Magnetic Tape Manufacturing Industry
Background Information for Promulgated Standards
Final Environmental Impact Statement

EPA-450/3-85-029b
July 1988

Magnetic Tape Manufacturing Industry — Background Information For Promulgated Standards

Figure 2-1. VOC penetration of activated carbon adsorption bed at time T_1 .

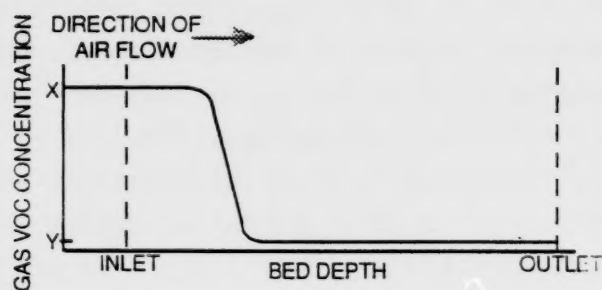
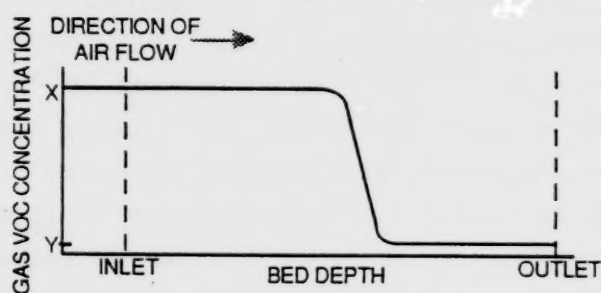
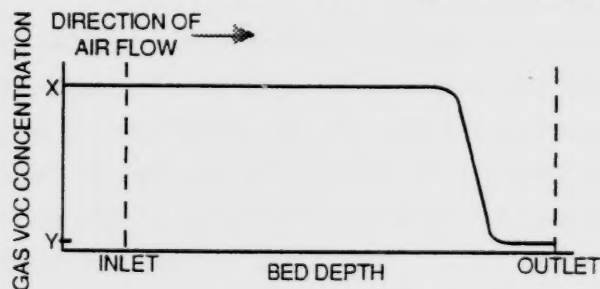
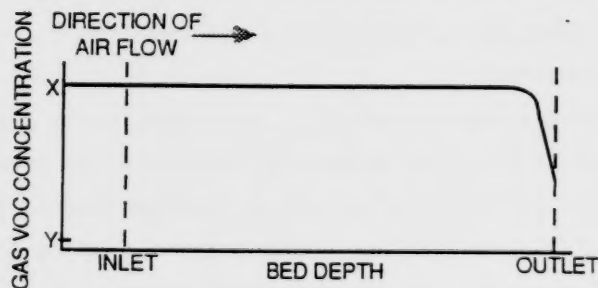
The commenter specifically questioned whether any supporting data exist for the Agency's position that 95 percent VOC removal efficiency can be achieved continuously by carbon adsorption systems over all averaging periods, including short-term periods. The commenter submitted information which indicates 24-hour averages of efficiency of his adsorption system vary dramatically from day to day. Highs above 95 percent were followed quickly by lows of less than 90 percent, with no short-term pattern evident.⁷ It was this information that caused the commenter to question the Agency's decision to require corrective action by a source based on short-term evidence that the efficiency of the adsorber has failed to meet the required level of control.

Figure 2-1 illustrates how quickly and dramatically carbon removes organics from an airstream. It shows the concentration profile of an airstream at some time, T_1 , after a carbon adsorber bed is placed on stream. Figure 2-2 illustrates the concentration profile at a later time, T_2 , and Figure 2-3 presents the concentration profile at a still later time, T_3 . Figure 2-4 represents the concentration profile at a time, T_4 , after breakthrough has occurred.

Figures 2-1 through 2-4 represent the instantaneous performance of a carbon bed at specific times during a single adsorption cycle. As stated above, Figure 2-5 represents the outlet concentration curve from the same bed over the same period of time. None of the figures demonstrate the effect of fouling, which is appropriate because fouling does not affect instantaneous performance or outlet concentration. Rather, the effect of fouling is measured in terms of the length of each adsorption cycle.

Good operating practice would cause him to replace the carbon before the adsorption cycle is equal to the combined times required for steaming and cooling. If he does not replace the carbon, however, he is forced to compromise either by leaving one bed on stream too long with the attendant losses after breakthrough or by placing in service a bed that has not been properly regenerated. The latter action would reduce overall efficiency because of the reduction in adsorptivity and, subsequently, the equilibrium capacity and the working capacity. Premature breakthrough would be inevitable and instead of exhausting at concentration Y (see Figure 2-1), the outlet concentration could be significantly higher.
